PROPOSAL AND CONTRACT DOCUMENTS

Construction Necessary to Improve the Parking Lot & Drive for the Stadium
& Lab Complex, known as State Project No. BWO-9001-25(009) /
501464, in the County of Hinds, State of Mississippi.

PROJECT: BWO-9001-25(009) / 501464 -- HINDS COUNTY

FIGURE 1 - REFERENCE DIVISION 100 - PAGE 101-1

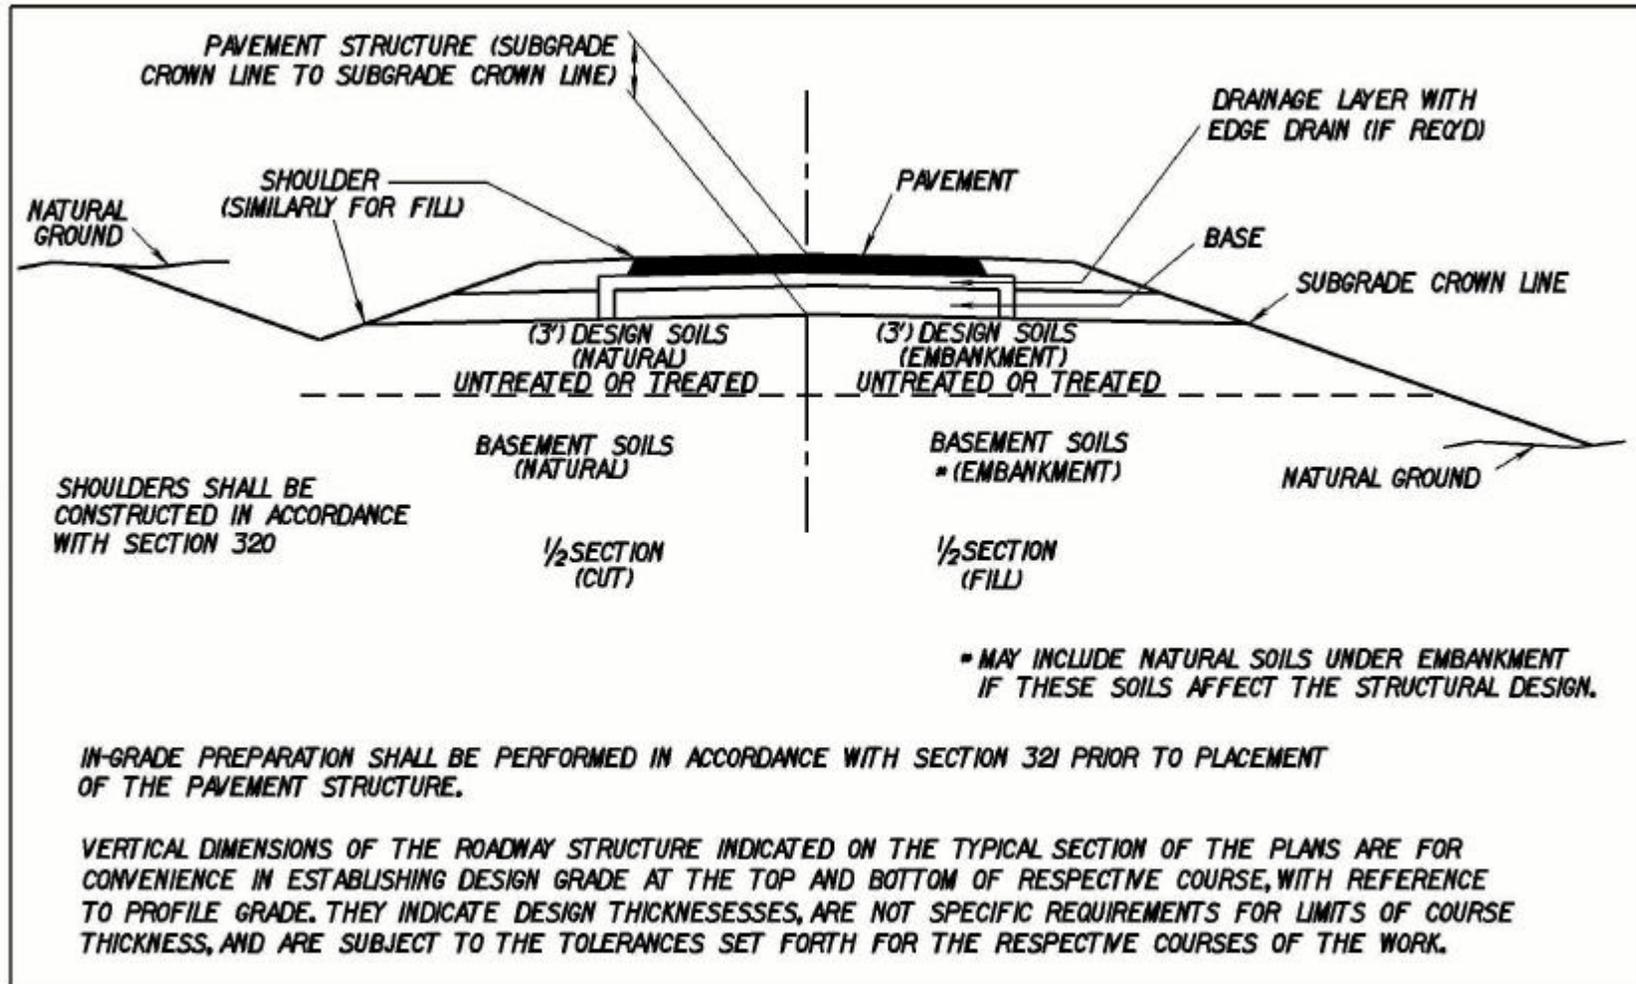
| Delete Figure 1 at the end of Section 101 on page 101-13, and substitute the following:
